MIL "ON" DTC P0401 and/or Rattle After Cold Soak

SUPERSESSION NOTICE

The information contained in this bulletin supersedes SB No. T-SB-0075-13.

Figure 3.

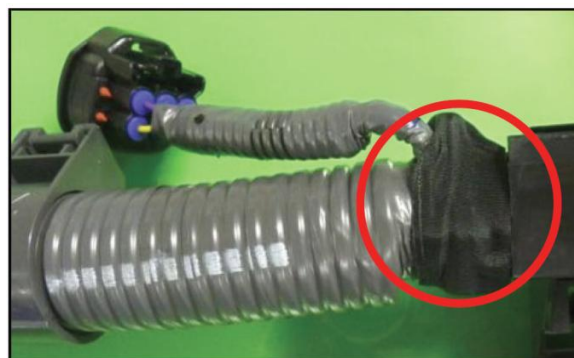
C. Wrap the exposed zip tie 7 – 8 times with heat resistant vinyl tape.
